September 24, 2009

Subject: Approval of Two Work Plans With Modifications; Fuel Leak Case No. RO0000143 (Global ID # T0600100304), Chevron #9-0020, 1633 Harrison Street, Oakland, CA 94612

Boring Log and Well Completion Details  
MW-9 (Boring B-16)

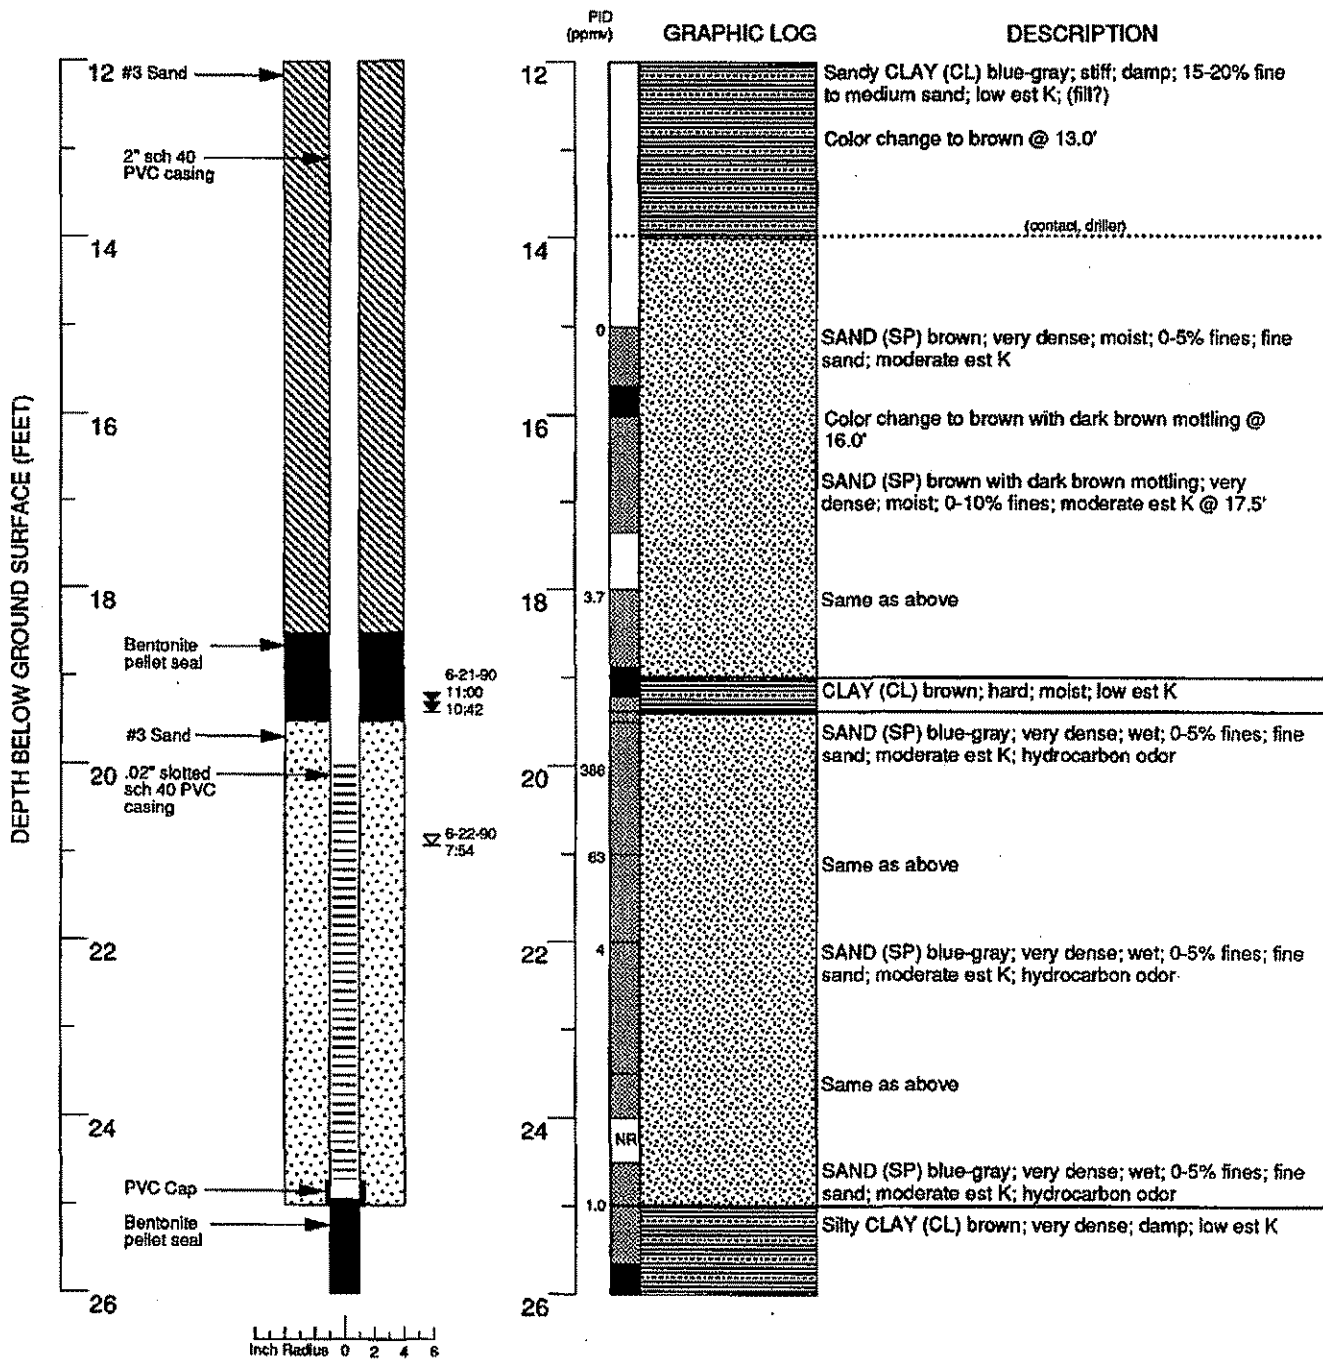
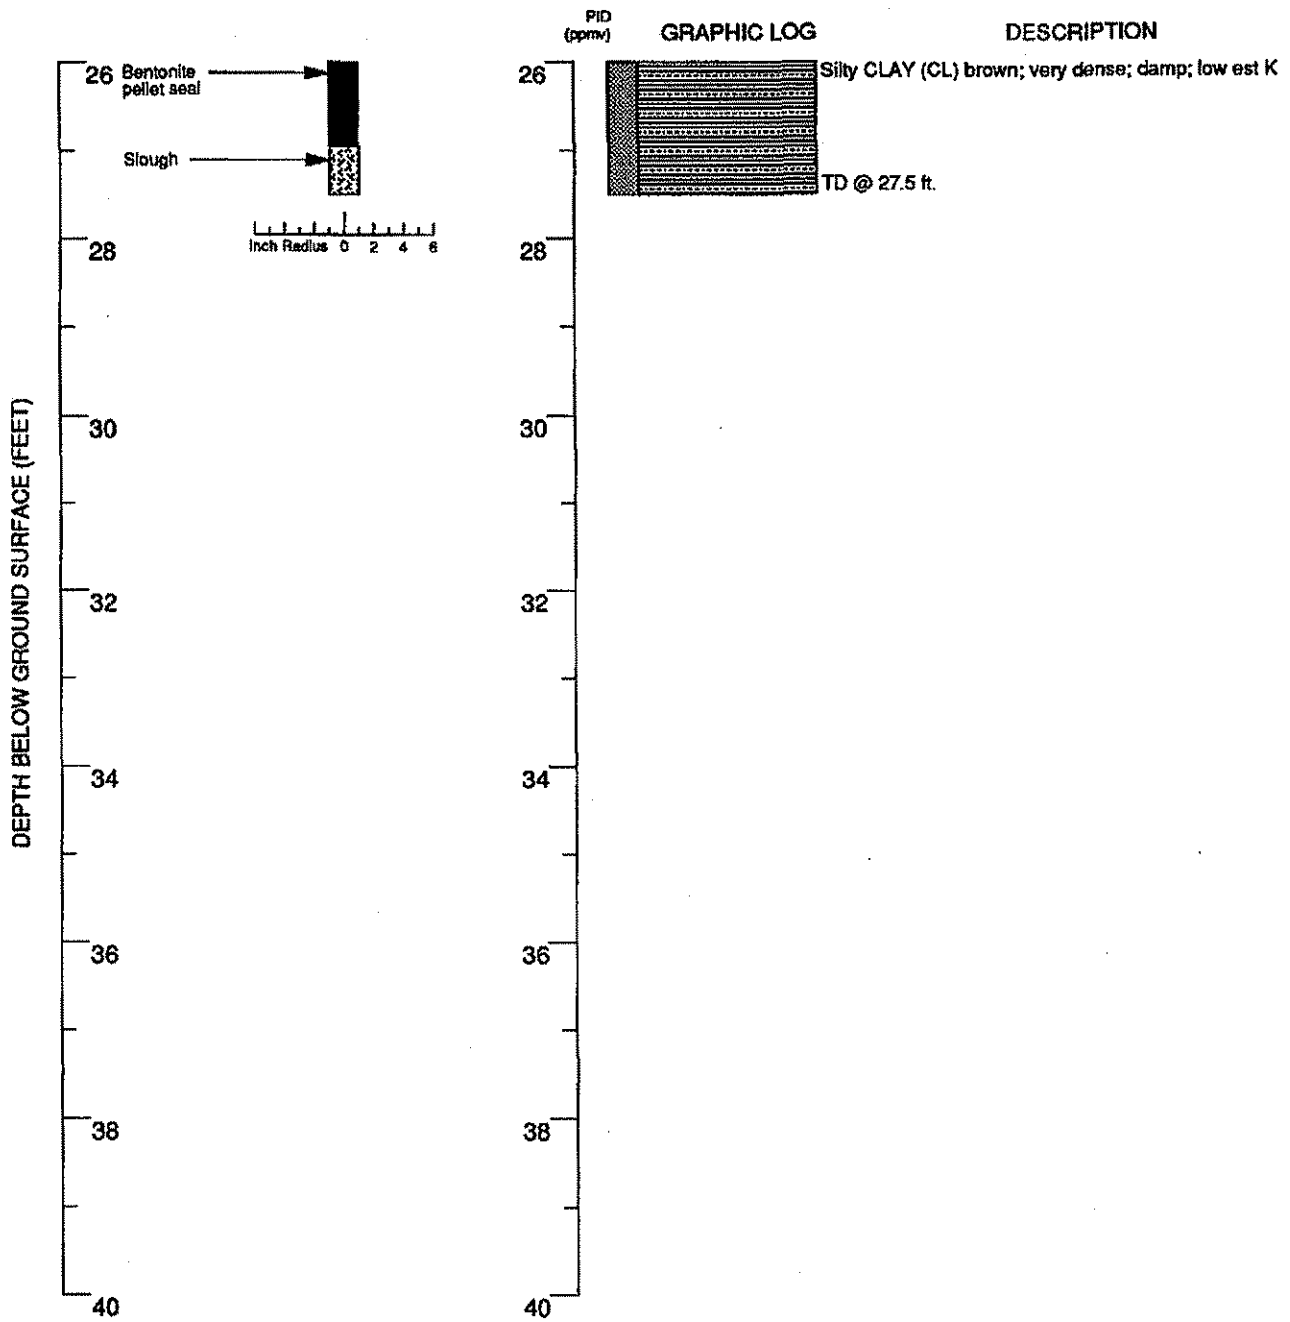
- d. **Well MW-17 Screen Interval** – The June 11, 2009 work plan indicates that the well screen will be 10 feet in length between 15 and 25 feet bgs. In general, ACEH generally recommends the use of monitoring wells designed with sand pack intervals of 5 feet or less; as these wells will likely be representative of depth discrete groundwater conditions. ACEH in particular calls to your attention the well and bore log for downgradient well MW-9, wherein an apparent 4-inch thick clay within a 11 foot section of fine sand separates the vadose zone from an impacted water-bearing zone. This well used an appropriate 5-foot well screen between 20 to 25 feet bgs (see attachment).
